City of Evansville **Plan Commission**
Regular Meeting
City Hall, 31 S Madison St., Evansville, WI 53536
Tuesday, June 11th, 2026, 6:00 pm

SITE PLAN APPLICATION – STAFF REPORT

Applications: SP-2026-05, CUP-2026-07

Parcel: 6-27-1150 **Location:** 551 County Road M

SHEET NO. C3.0

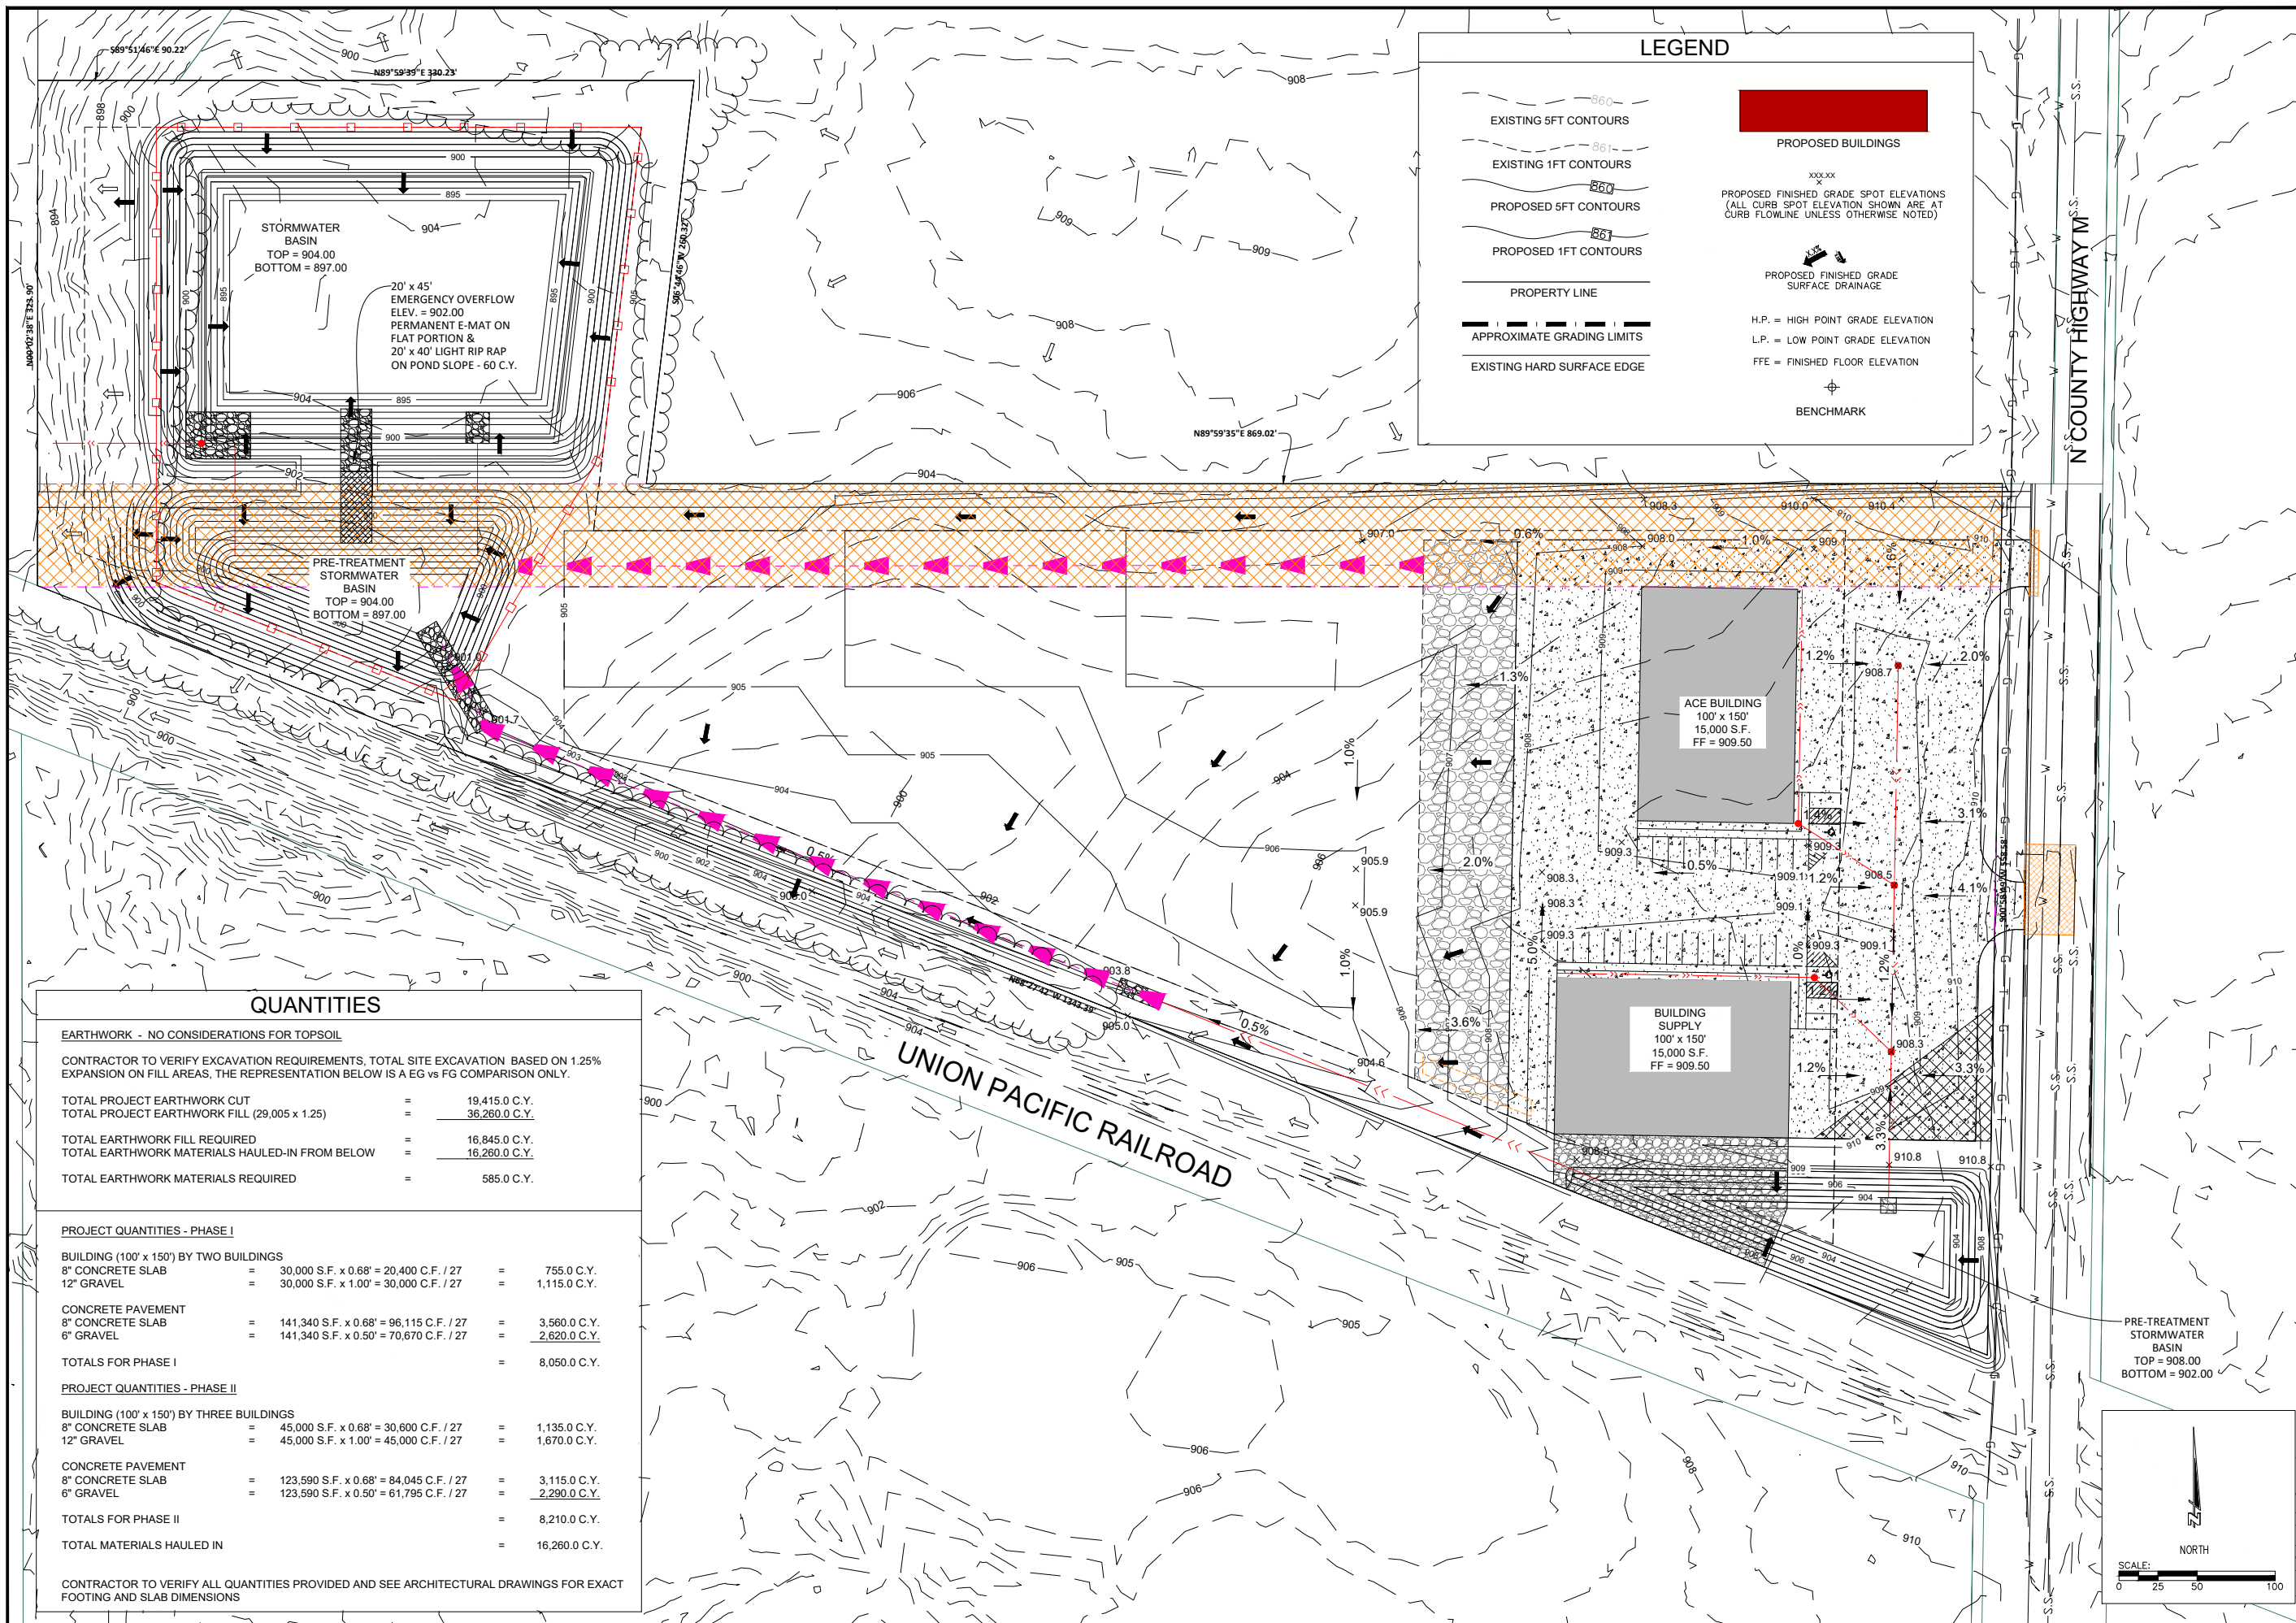
Shown on Sheet C3.0. Criteria met.

SHEET NO.
C8.0

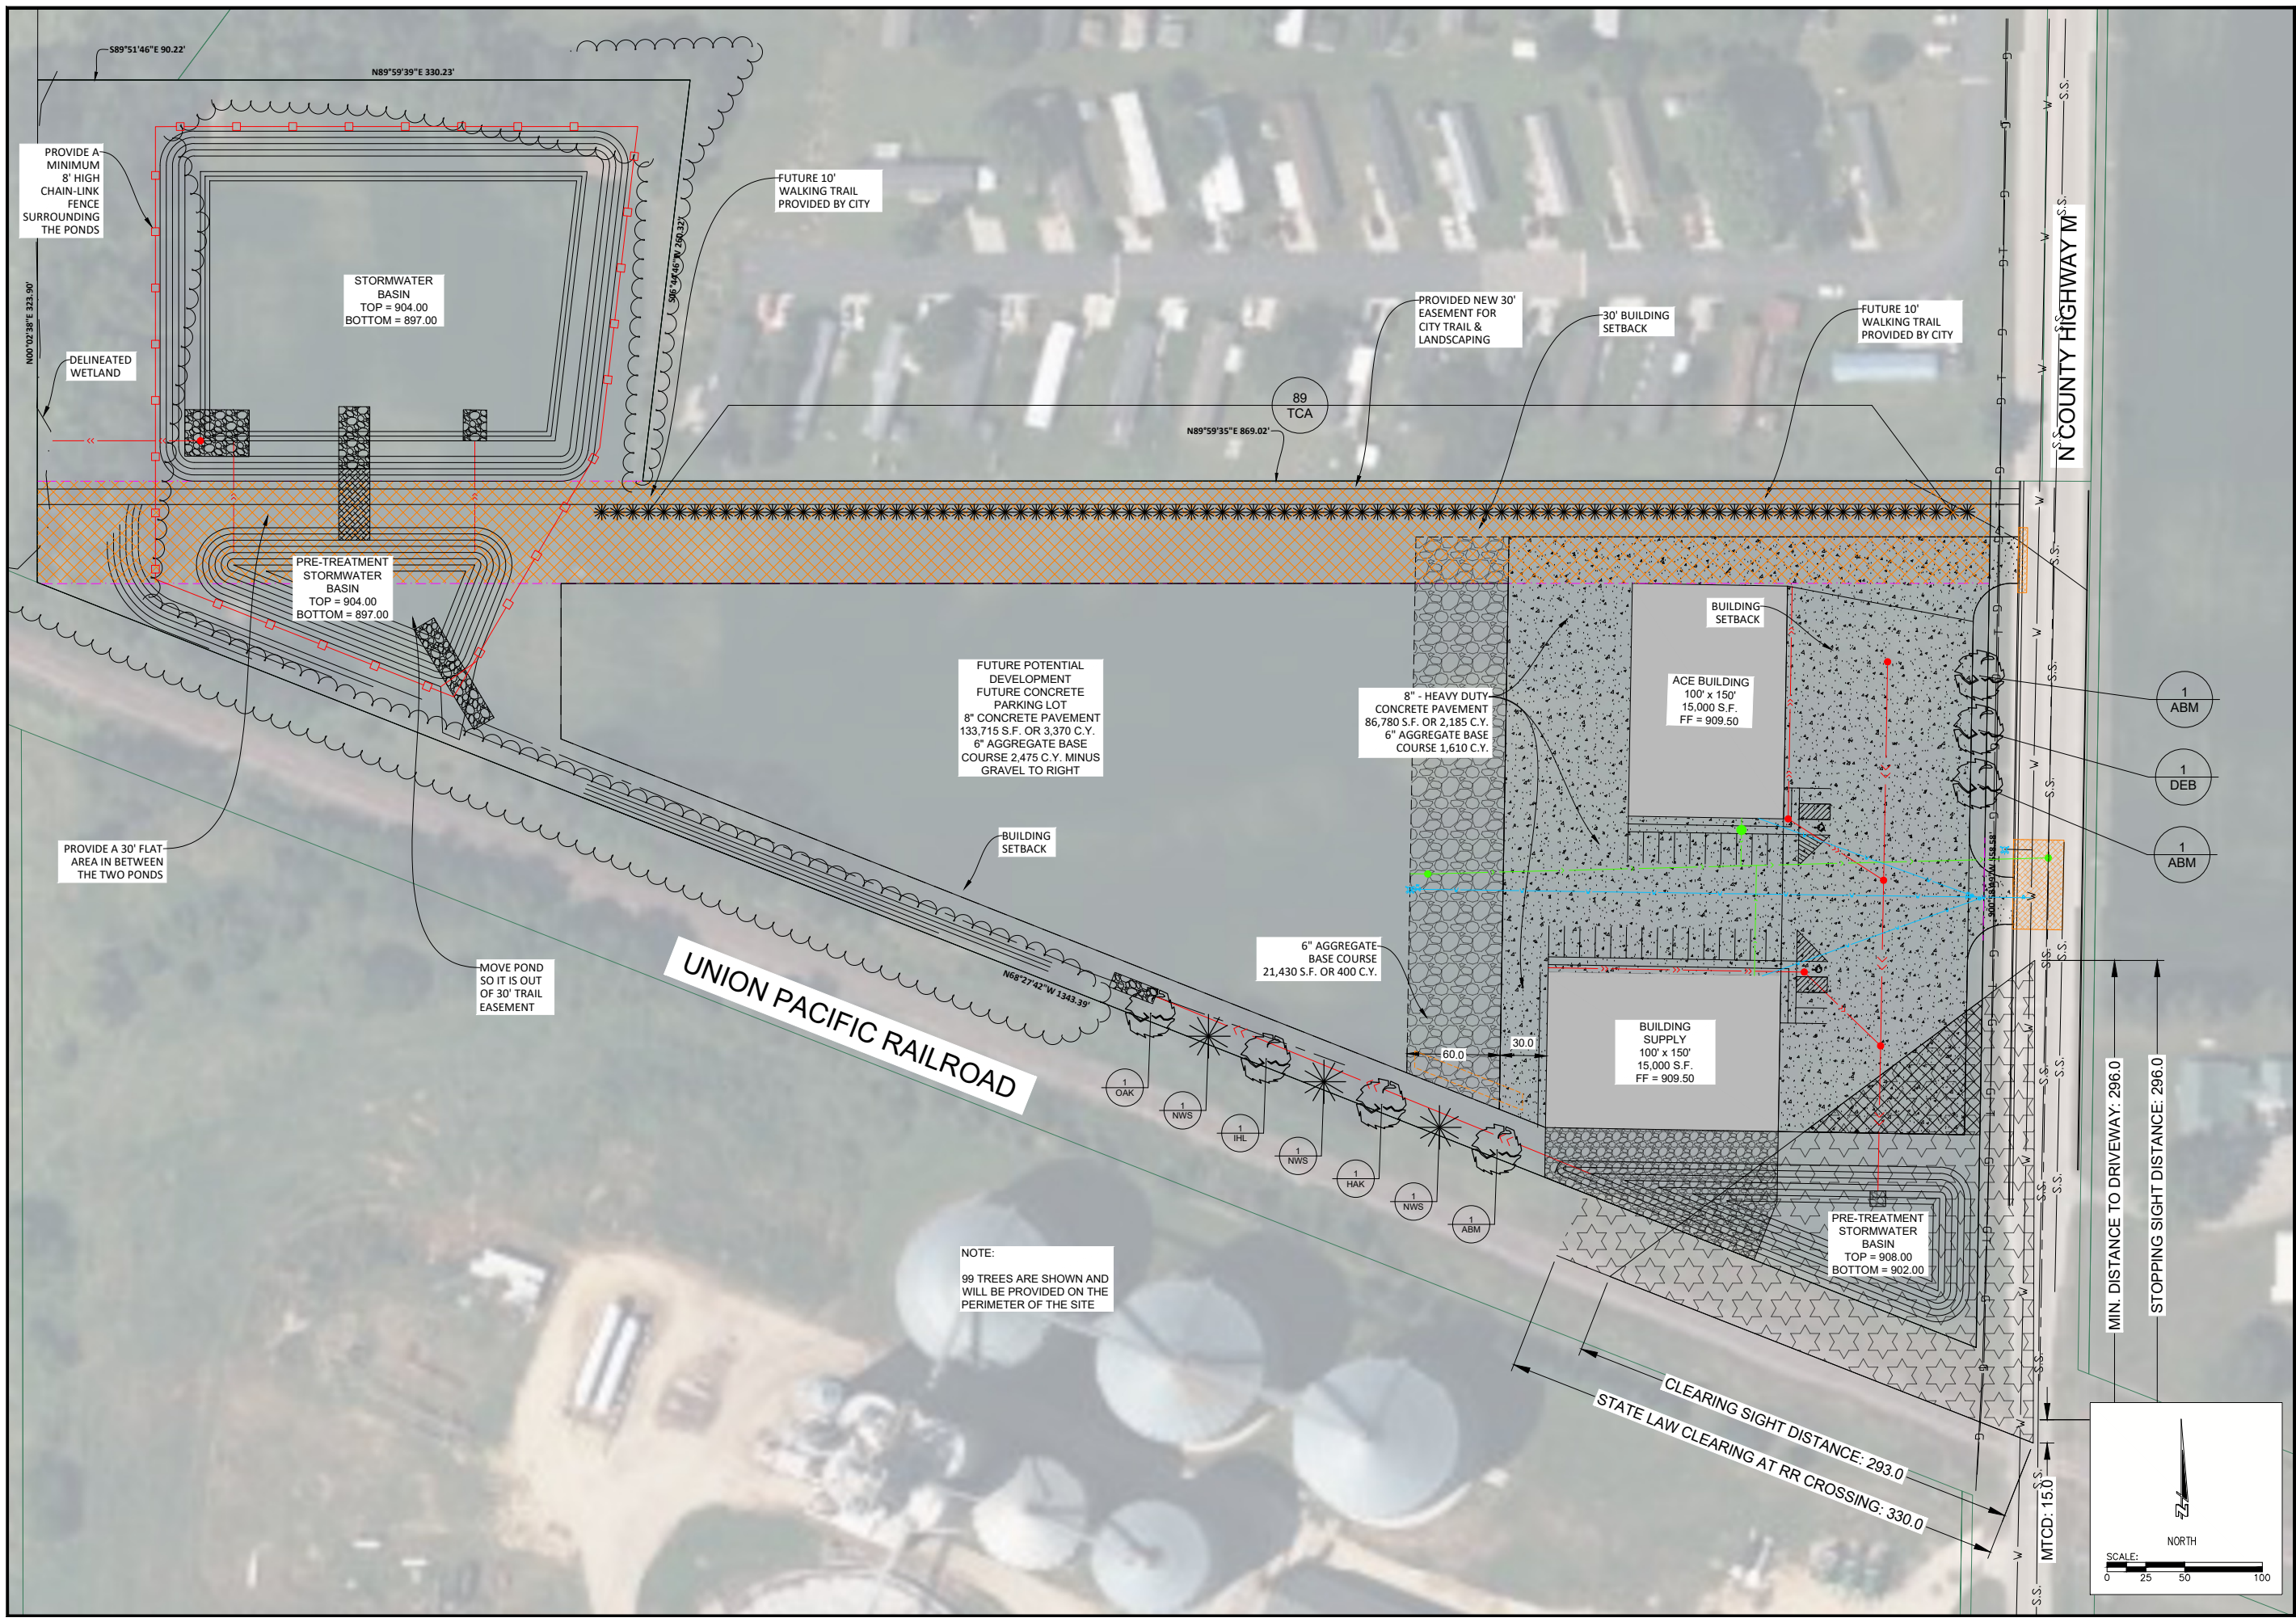
- Landscaping has been added along County Highway M and between the site and Midway Village Mobile Home Park. This site features tree cover in the far western part of the site; existing vegetation does count towards landscaping requirements. Staff finds that the addition of screening trees and existing vegetation satisfy the requirements.
